(54.6' - 99.9' - 88.5') PRESTRESSED CONCRETE NU GIRDER SPANS (SKEW VARIES)

BRIDGE NO. A9542

REV. 1 - NDC-002 - REVISED DIMENSIONS

BRIDGE: I-70 EB OVER HINKSON CREEK

DETAILS OF STAGED CONSTRUCTION

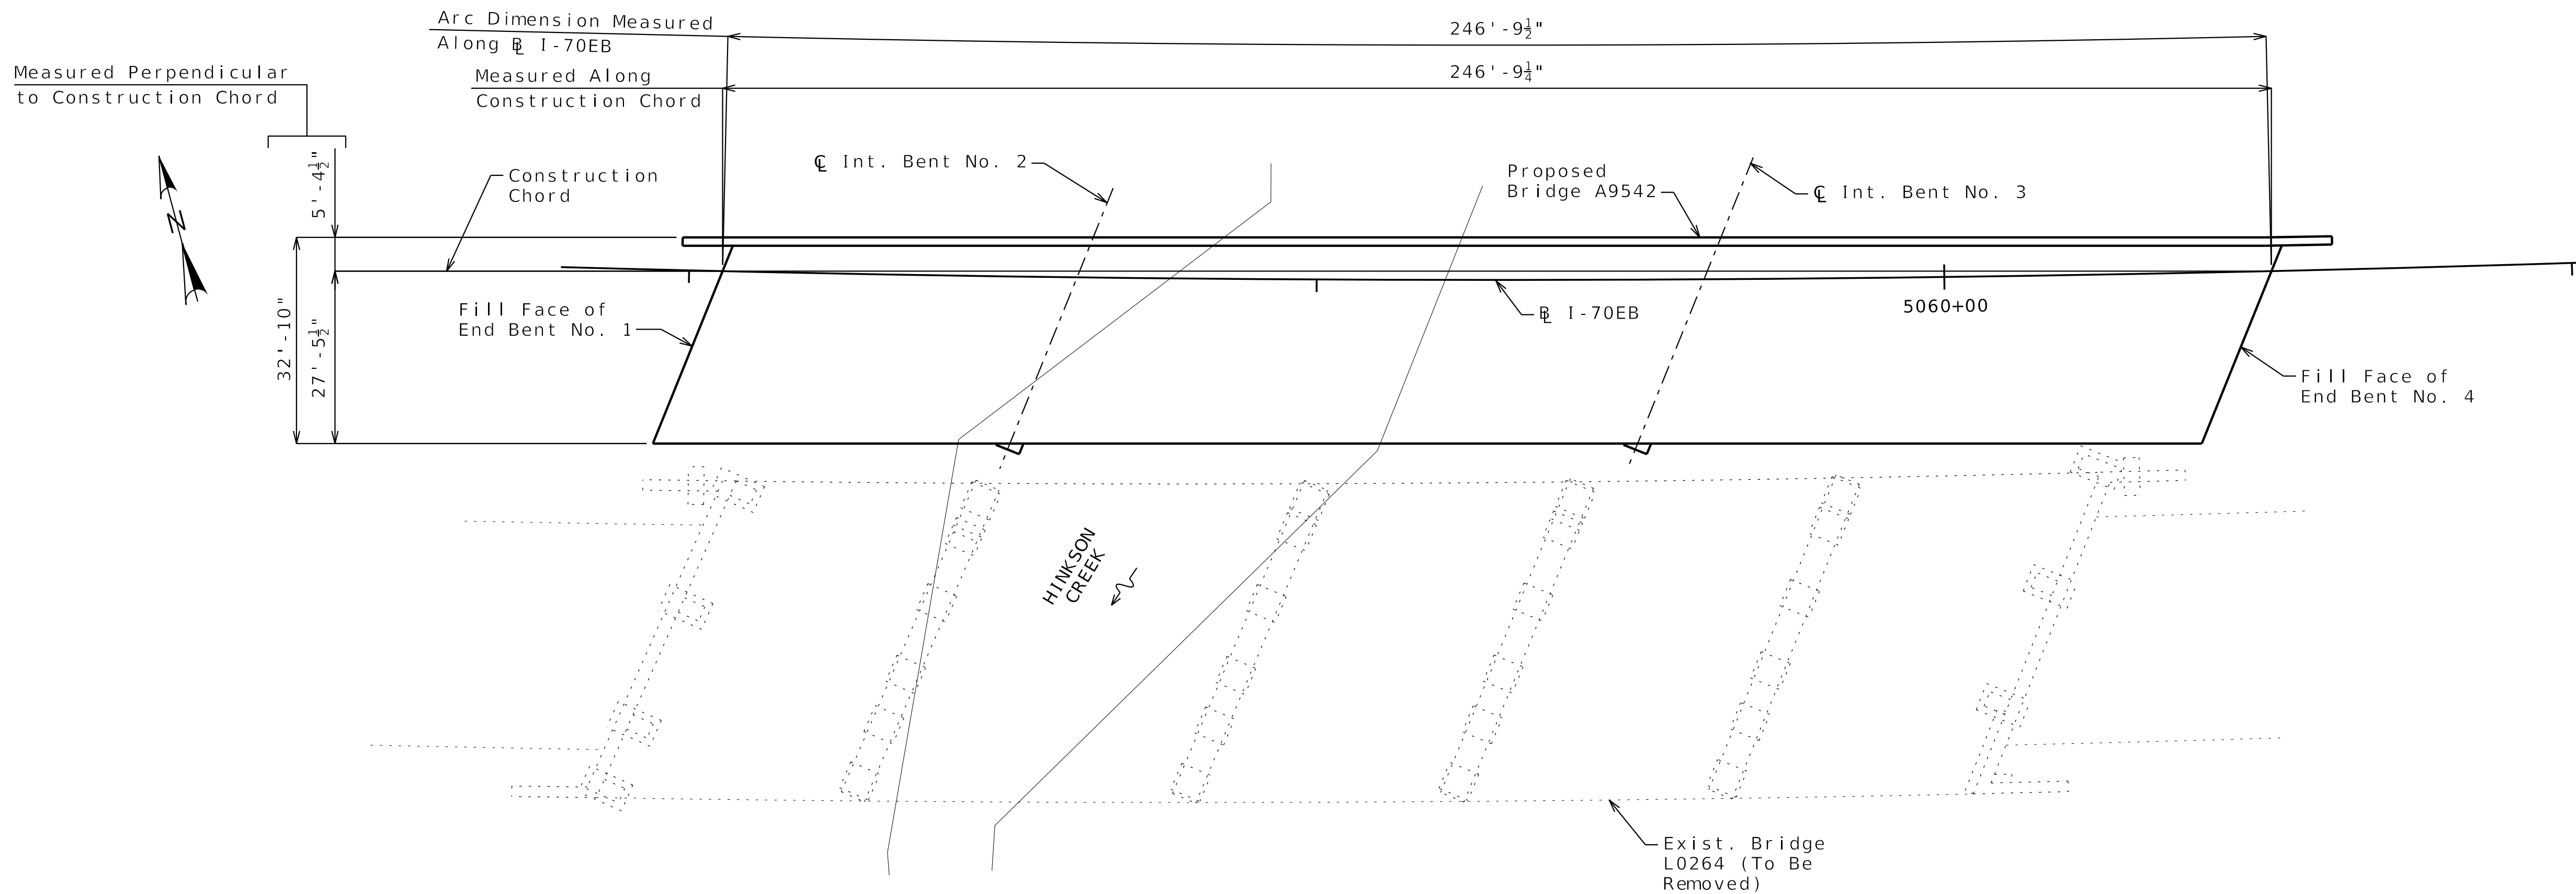
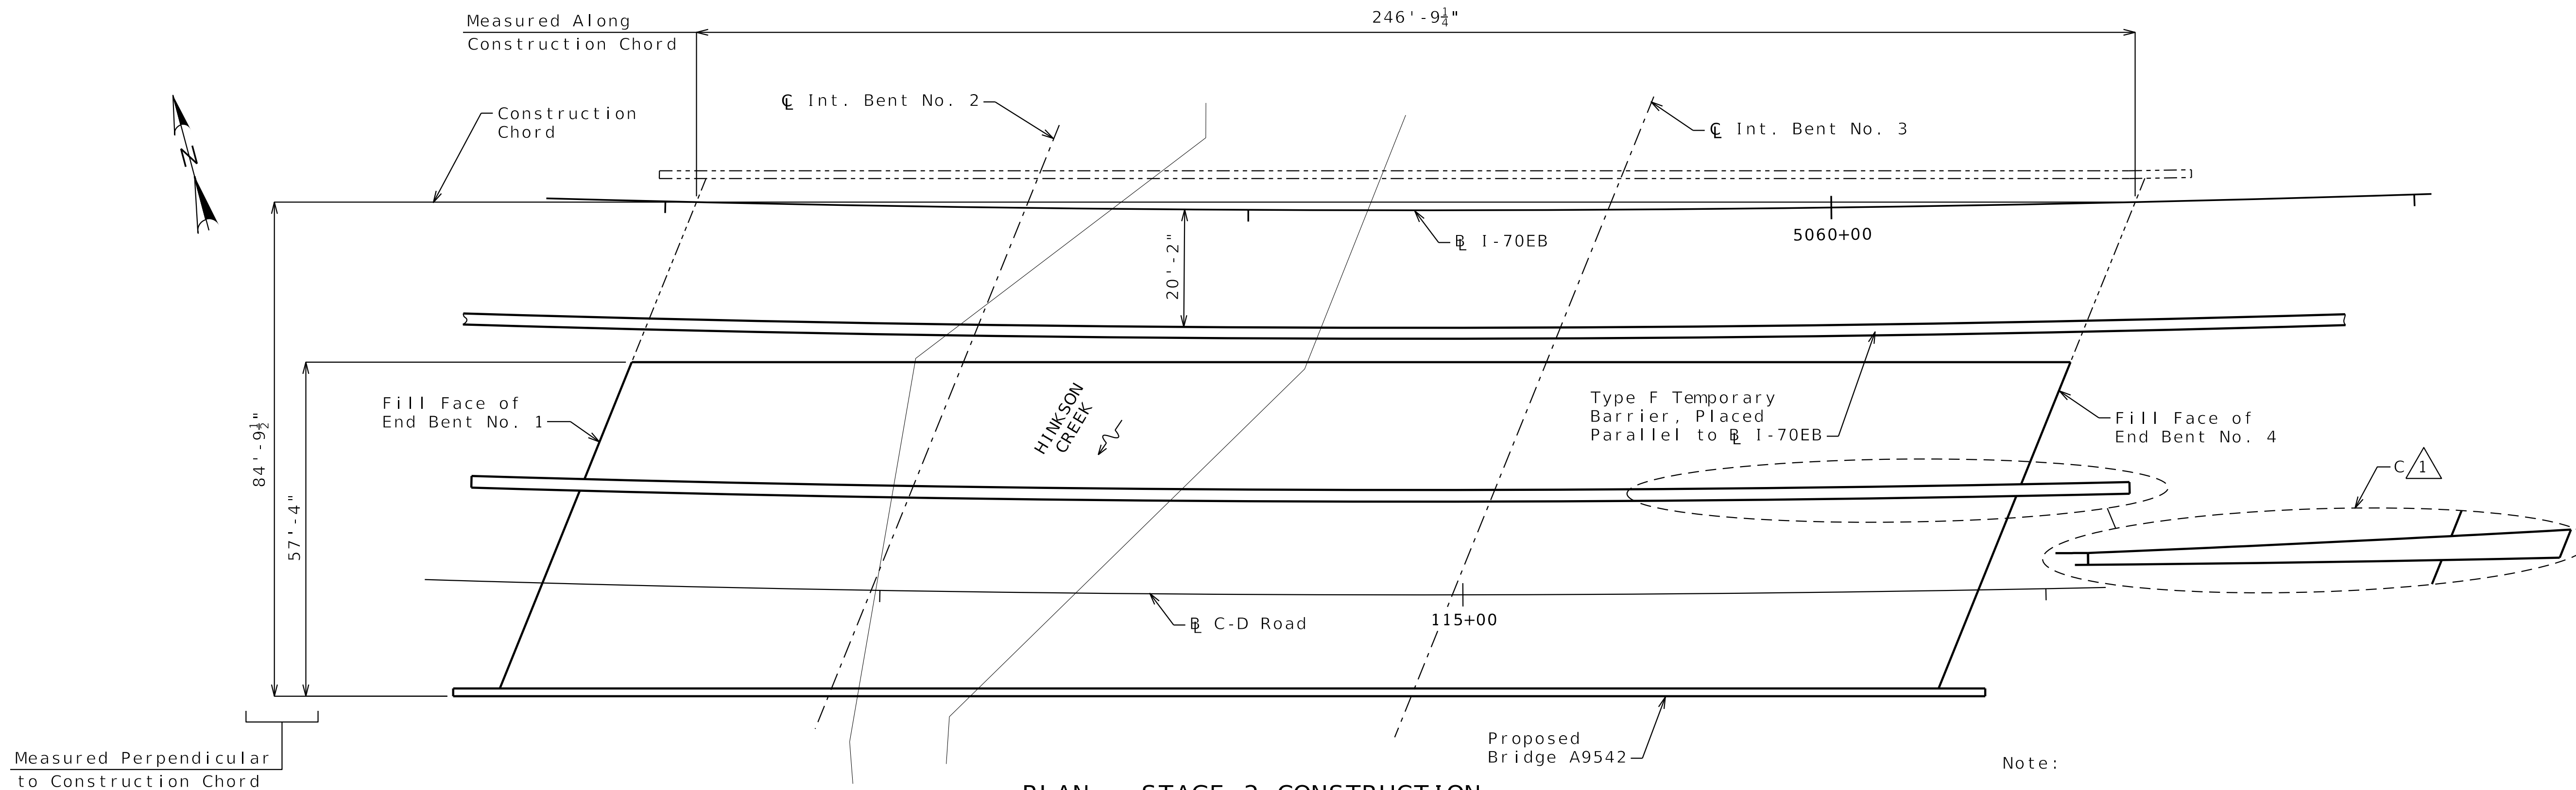
DATE	DESCRIPTION
09/13/24	REV. A - FINAL REVIEW
10/01/24	REV. 0 - RELEASED FOR CONSTRUCTION
12/23/24	REV. 1 - NDC-002 - REVISED BARRIER

DETAILS OF STAGED CONSTRUCTION

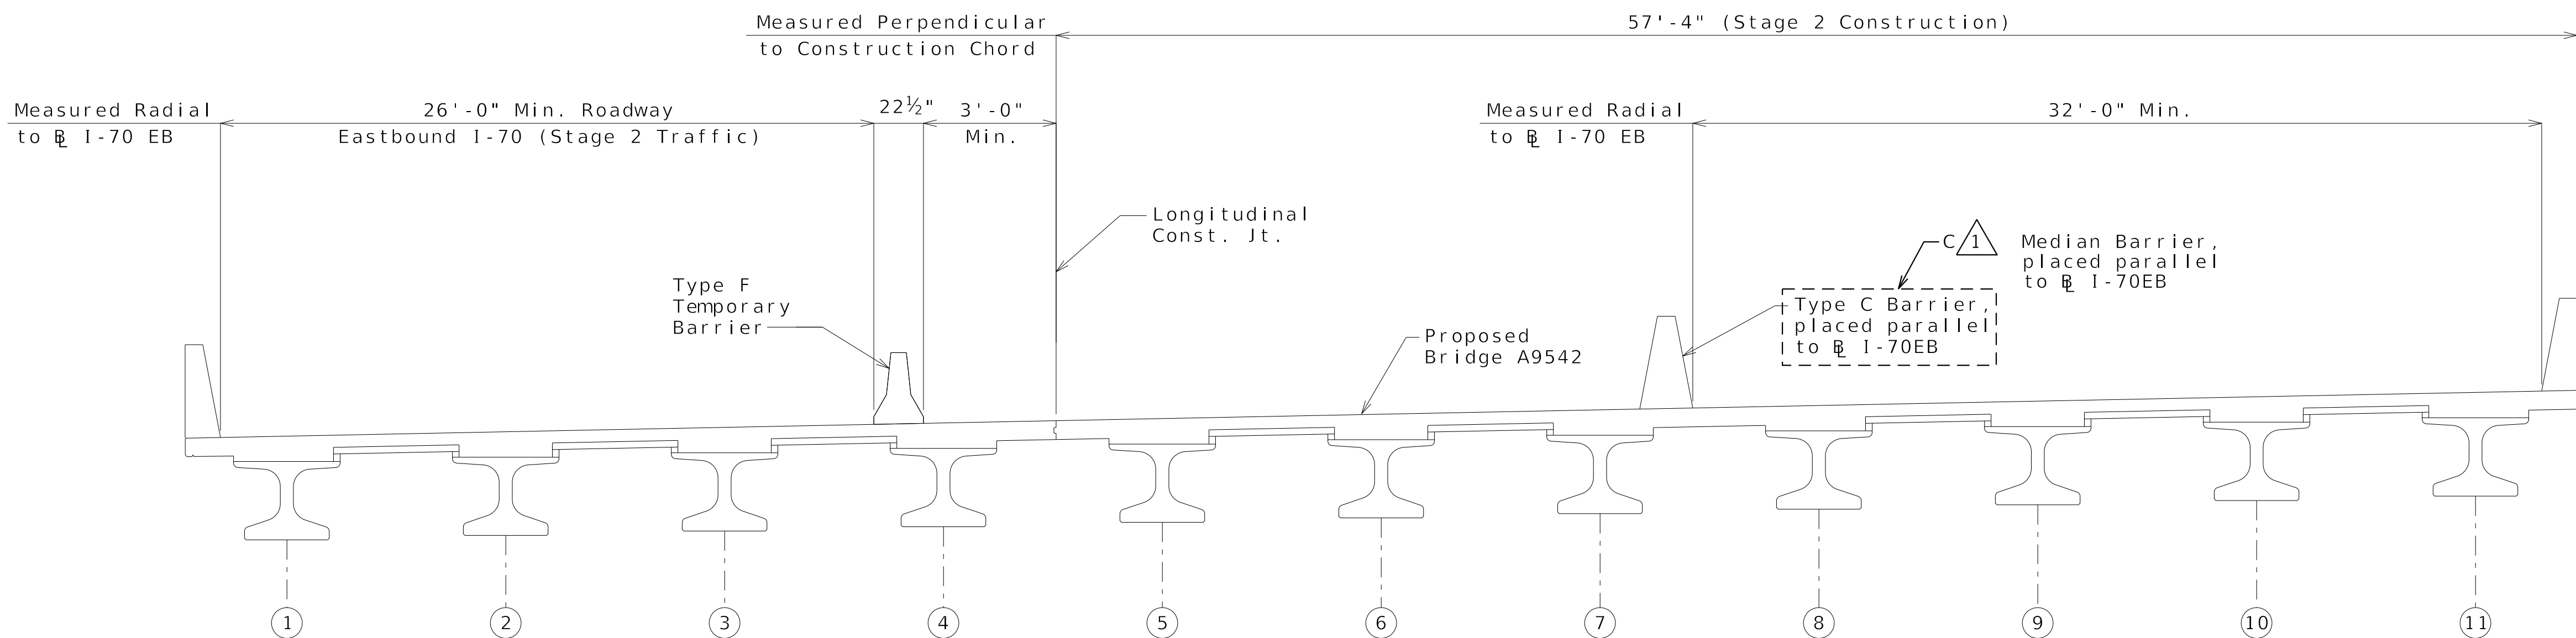
REV. 1 - NDC-002 - REVISED BARRIER
